# LIST OF VARIOUS Inspection Rpt. IN 75

U. S. NUCLEAR REGULATORY COMMISSION  
OFFICE OF INSPECTION AND ENFORCEMENT  
REGION IV

IE Inspection Report No. 50-285/75-06

Facility: Fort Calhoun Station, Unit 1

FIGURE - 1

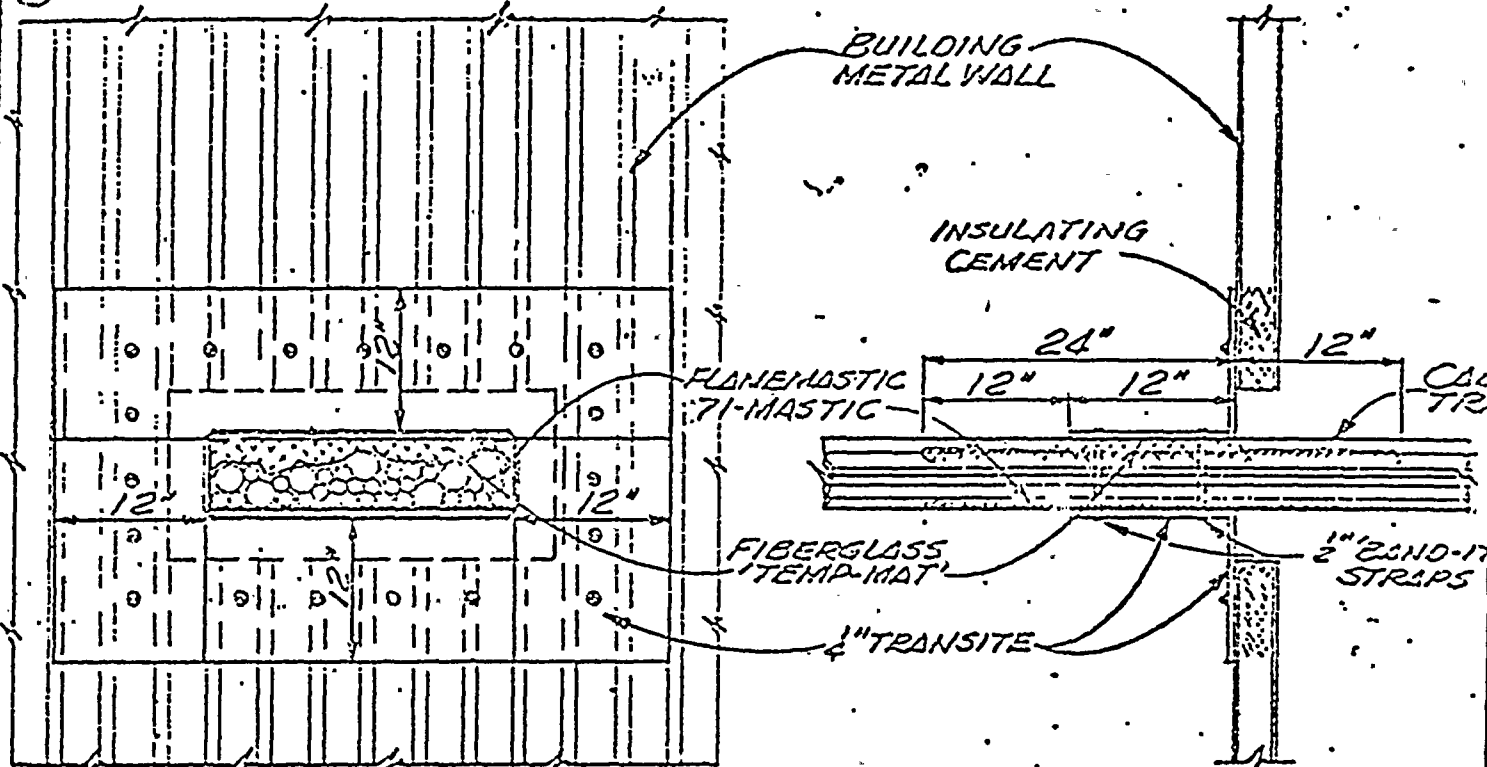
"The Turkey Point FSAR, Section 8, page 8.2-9 states, cable trays passing through walls or floors are provided with fire stops as shown in Figure 8.2-19." (See Figures 1 and 2 attached to this report) "A similar fire stop is provided where cables pass through floor slots, such as under control panels. A thermal resistant coating (such as Flamemastic 71A) is applied to cables in the cable spreading room, and to cables inside and outside the containment in the penetration area".

A construction installation procedure dated 4/10/70 identified as Job No. 5610, Dwg 5610-E-310, states in Section III, "Raceways passing through walls, ceilings, or floors shall have a fire stop such as shown on Florida Power and Light drawing A-GO-4 and A-GO-5." These drawings are the same as shown in the FSAR and are appended as Figures 1 and 2 of this report.
